PLANNING BOARD AGENDA
AMENDED

April 14, 2025
REGULAR MEETING

**Re: Joseph Stuto Land Use Application
399 North Boulevard, Lake Como**

**Re: Completeness/Technical Review #3
Stuto Use Variance Application
399 North Boulevard
Block 18, Lot 20
H2M Project No. LKCP2407**

00 PLOT PLAN 00
1" = 10'-0"

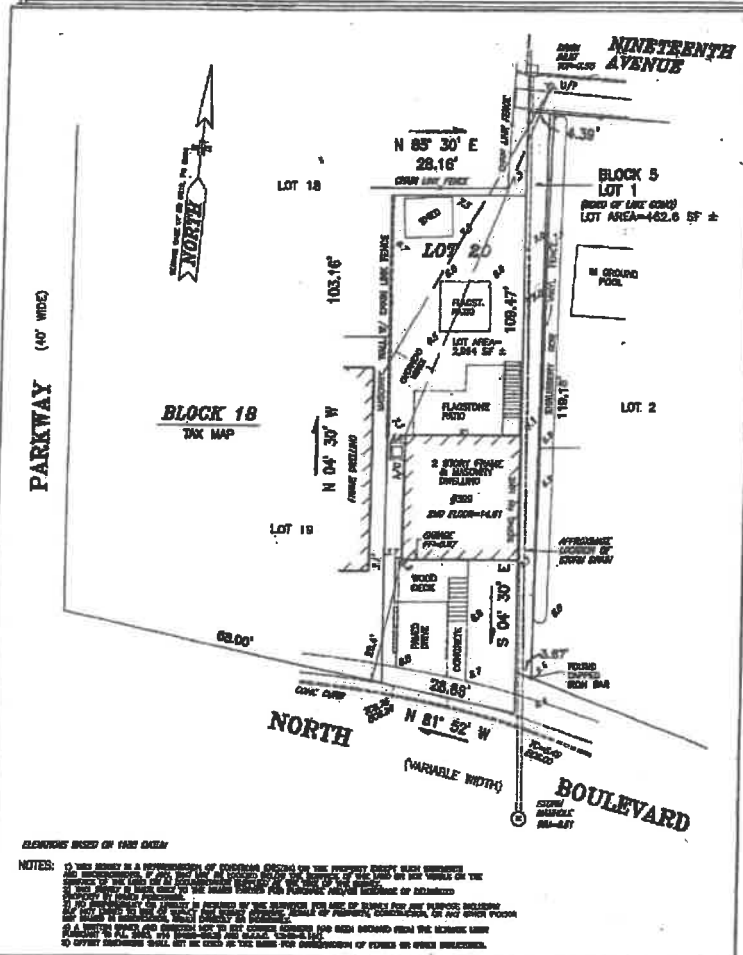
2. There is no Grading Plan provided and topographic contours/elevations are not represented on the Plot Plan. There is no information provided regarding intended stormwater management at the site. The Board should elicit testimony regarding stormwater management and condition any approval on submission of an acceptable Grading Plan.
3. The Plot Plan and survey do not depict an easement for the sidewalk that is located on the property. The Board should consider any approval on the Applicant providing an easement to permit the existing sidewalk to remain as part of this application.
4. Sheet A-7 appears to be an unscaled close-up of the property survey with hatching in the previously mentioned adjacent land strip. This sheet should be modified as it promotes confusion with respect to the adjacent Borough property and its relationship to the Applicant's property.

4. The Plot Plan and survey do not depict an easement for the sidewalk that is located on the property. The Board should consider any approval on the Applicant providing an easement to permit the existing sidewalk to remain as part of this application.

A-6

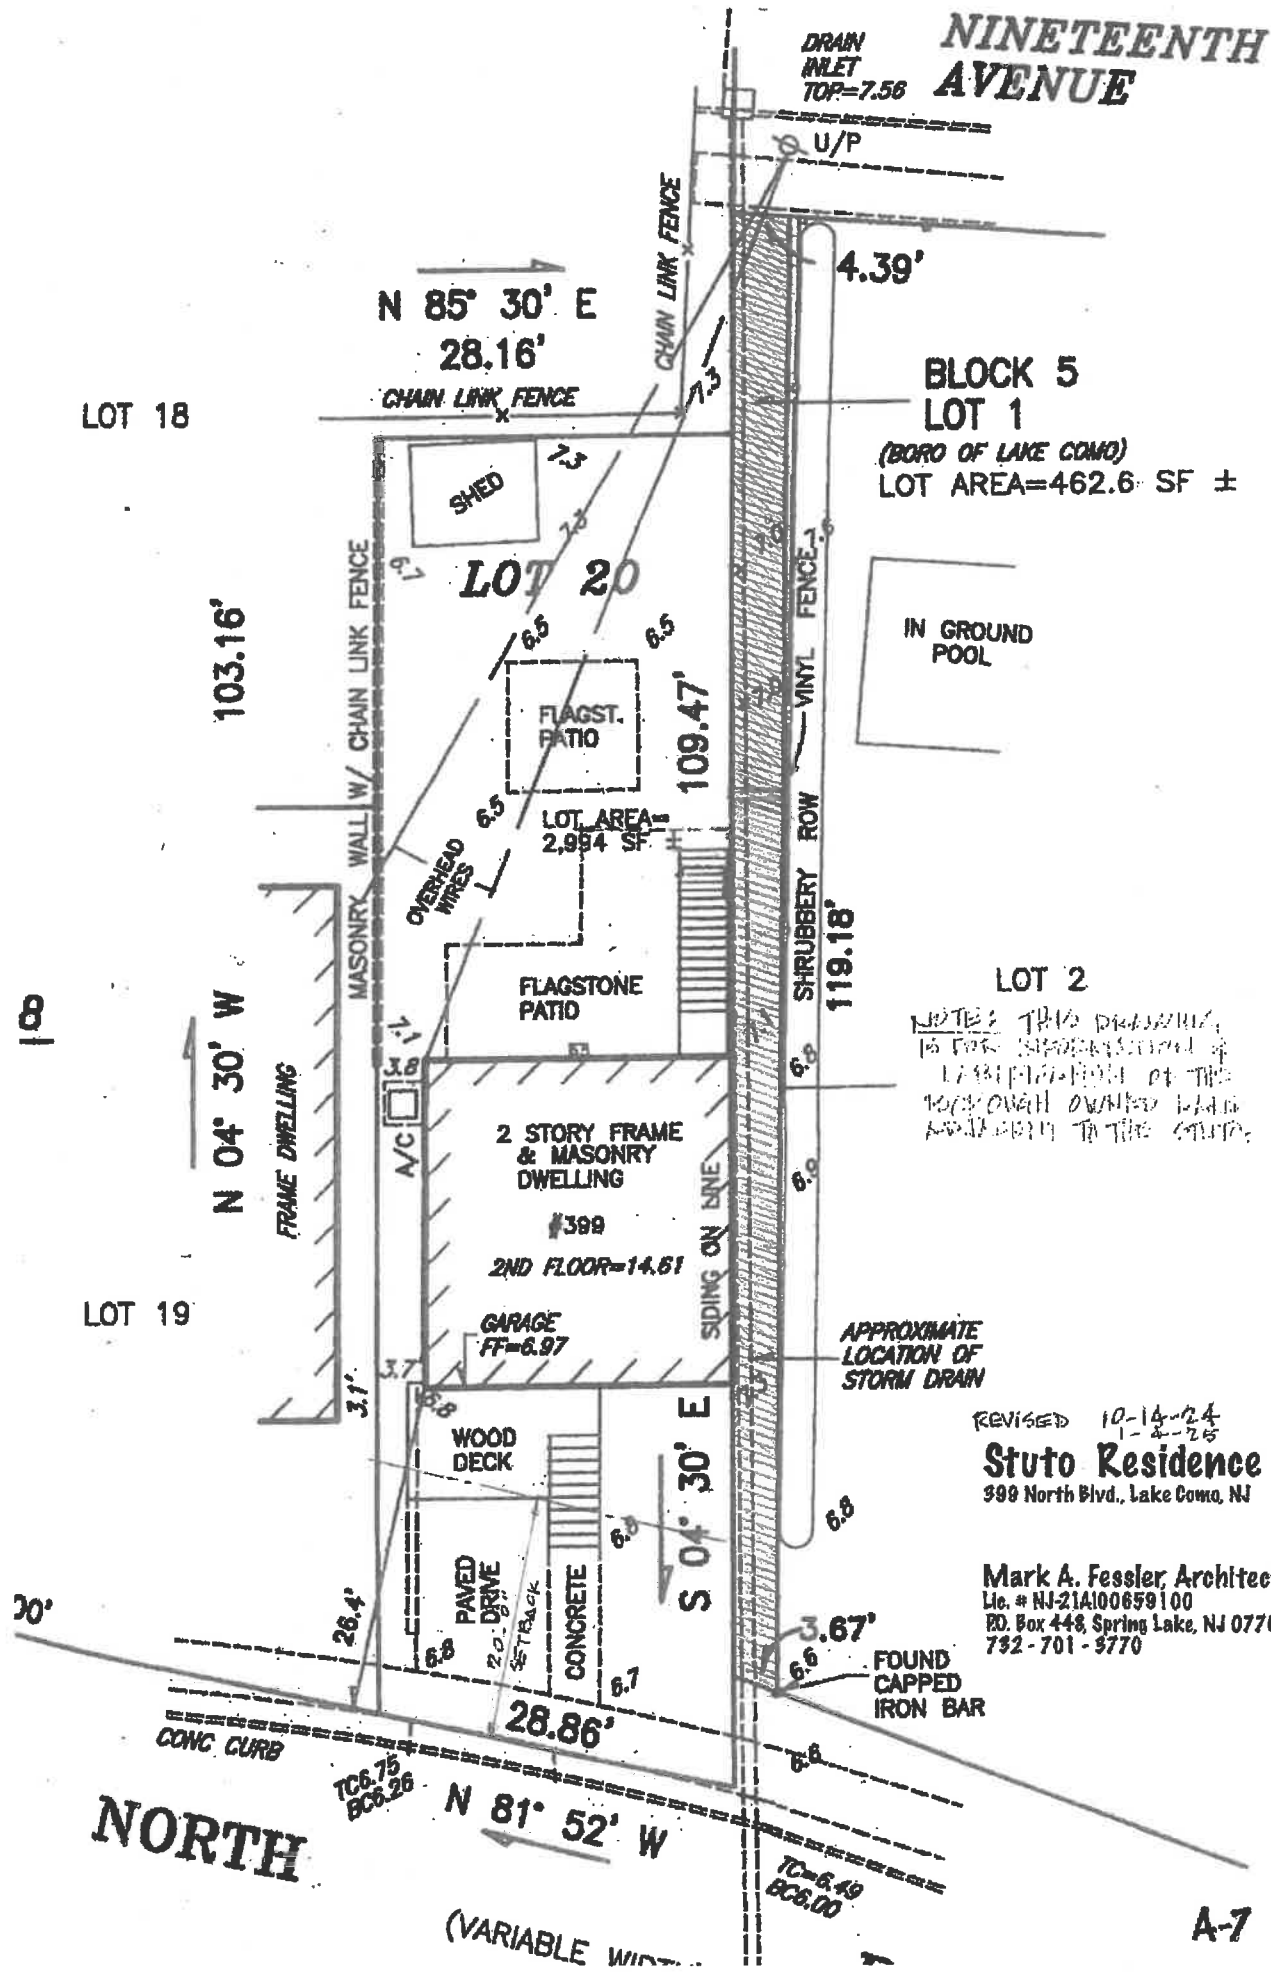
* The values reported above for Building Height, Building Area, and Impervious Area differ from the table on Sheet A-2 of the Architectural Plans. The values utilized in the table were not reproducible and were found to be variance conditions by our calculations which were based on scaling of the provided plans.
